### APARTMENT DESIGN GUIDE COMPLIANCE TABLE

**DA24/0196 - demolition of existing structures and construction of shop-top housing comprising three levels of basement carparking, ground floor retail premises and 72 units, pool and associated vegetation removal (NRPP) at Lot 1 DP 807977; No. 3 River Terrace TWEED HEADS; Lot 2 DP 807977; No. 5 River Terrace TWEED HEADS; Lot 5 DP 9056; No. 7 River Terrace TWEED HEADS**

**Date:** 27 May 2025

*Above: Overshadowing diagrams with 100-104 Wharf Street highlighted.*

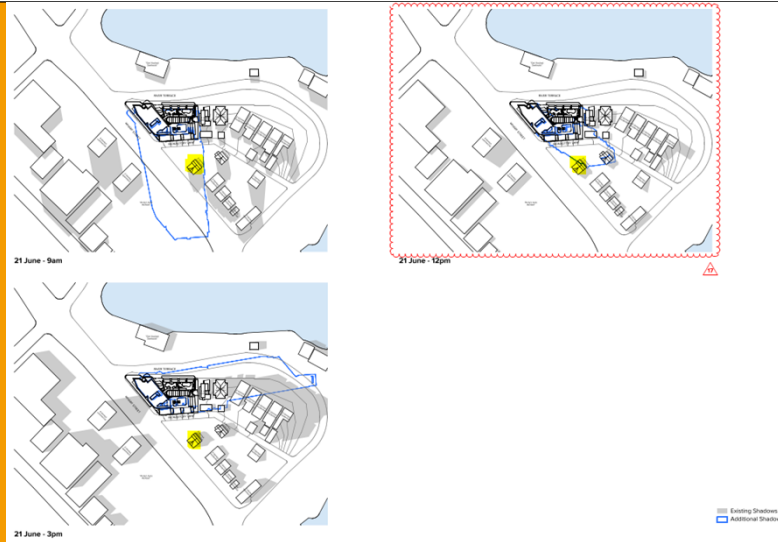
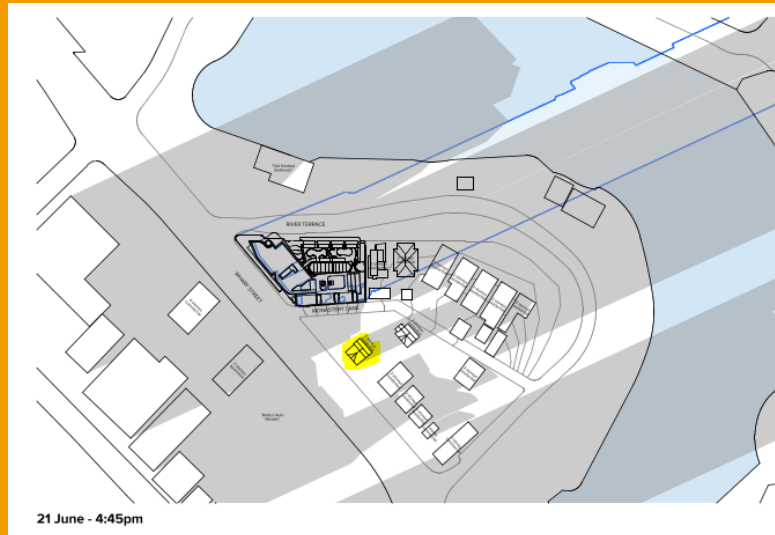
<p>retains sunlight only 12pm-2.30pm (approx))</p>	<p>of sunlight from approximately 12.00pm–2.30pm. Noting the intervening approval of DA23/0314 and the substantial compliance with solar access for the remaining neighbouring sites, it is considered the solar access received by 100-104 Wharf Street is acceptable.</p> <div data-bbox="566 319 1176 1137"></div> <p>Above: 100-104 Wharf Street (left) and subject sites (right).</p>	
--	--	--

*Above: Overshadowing diagrams with 9 River Terrace highlighted.*

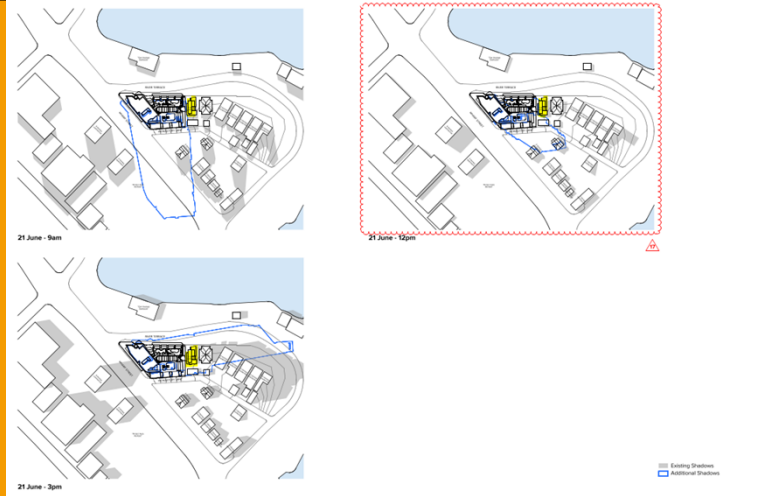
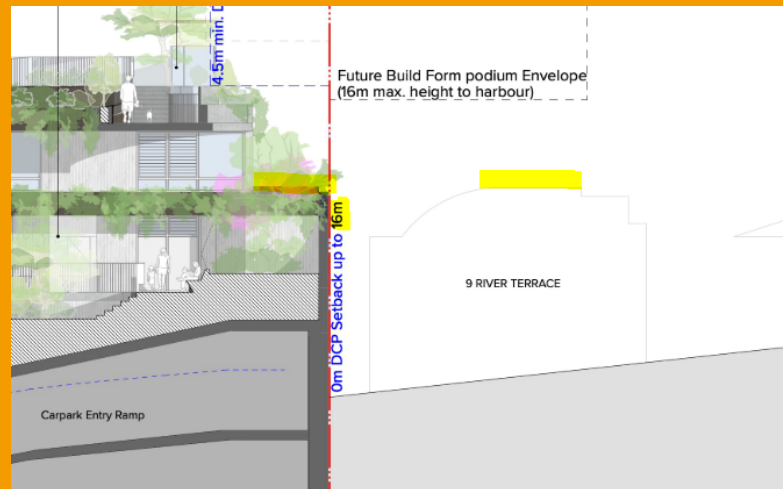
9 River Terrace directly adjoins the subject sites and will face a zero metre setback podium boundary wall approximately 1.9m from the subject dwelling.

Above: Overshadowing diagrams with 11 Monastery Lane highlighted.

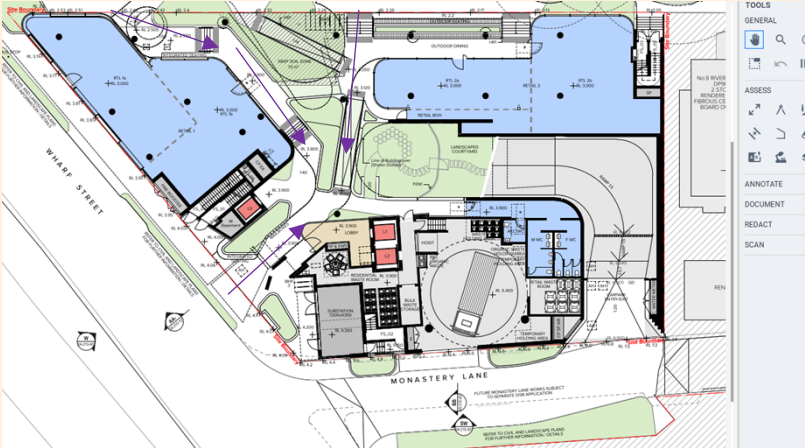
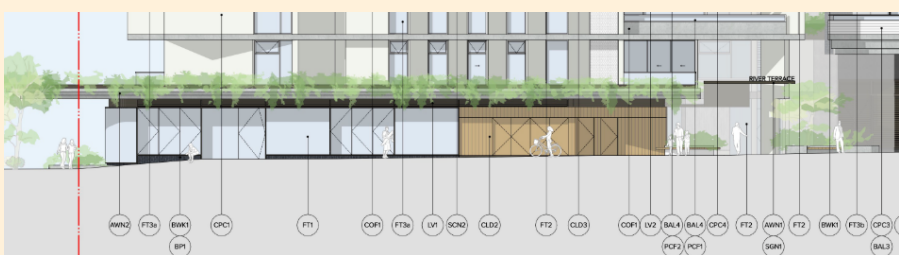
The site is occupied by a dwelling with the most recent addition (verandah) approved in 1359/2000DA. External living space (balcony) and living room are located and face River Terrace. Solar panels are located on the northern facing roof. 11 Monastery Lane retains similar solar access to 9 River Terrace. Solar panels retain a minimum 4 hours of sunlight.

Above: Roof plan above Level 13 showing grassed roof.

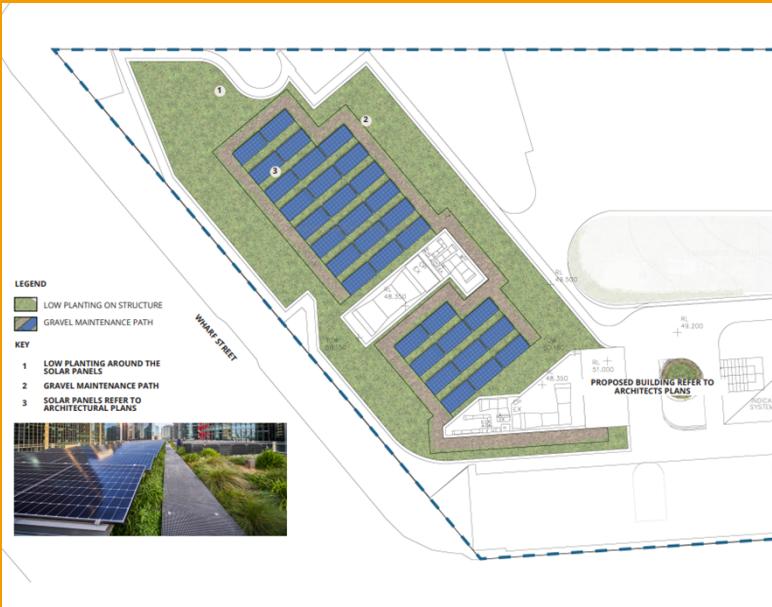
The roof level rooftop is the highest roof of the building above the Level 13 northern to the eastern edge of the tower/site. A walkway and grass is shown in the Landscape Plan. However, the Civil Plans note this area is non-trafficable and the elevations do not show any fencing. Accordingly, it is not included as relevant communal open space and a condition would be recommended for any consent restricting access to the rooftop.

*Above: Level 02 floor plan.*

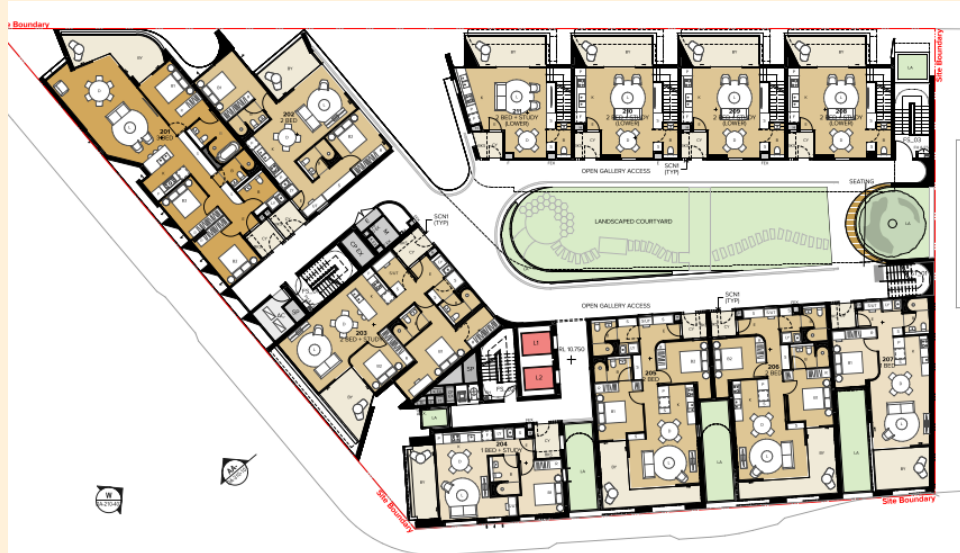
The four units at the top-right of the plan are separated from the remaining units by the gully cutout in the building. It is noted that a window from the kitchen of apartments 107 and 211 faces into 102 and 202 respectively with an approximate separation distance of 7.5-8.0m where 12.0m separation is required. A condition is

Above: MRV swept path showing reversing into site.

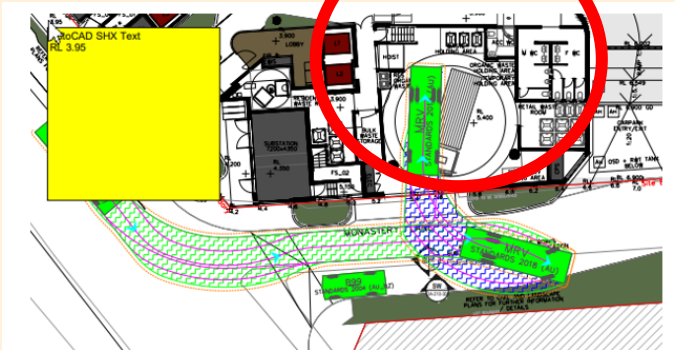
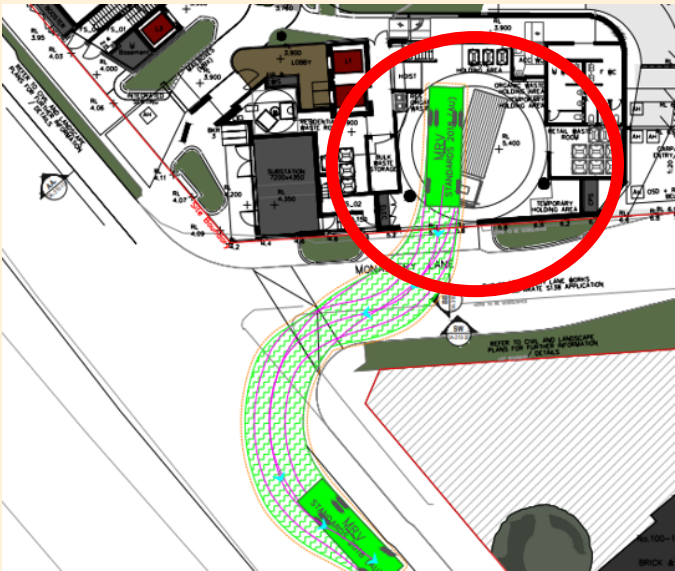
a forward direction. In this regard, Council’s Traffic Engineer notes the directly below submitted swept path shows the MRV reversing into the site. It is not considered that an MRV is unable to enter and exit in a forward direction and a condition has been recommended requiring same.

and exit in a forward moving direction  
with a condition requiring service vehicles accessing the site be limited to MRVs or smaller vehicles only
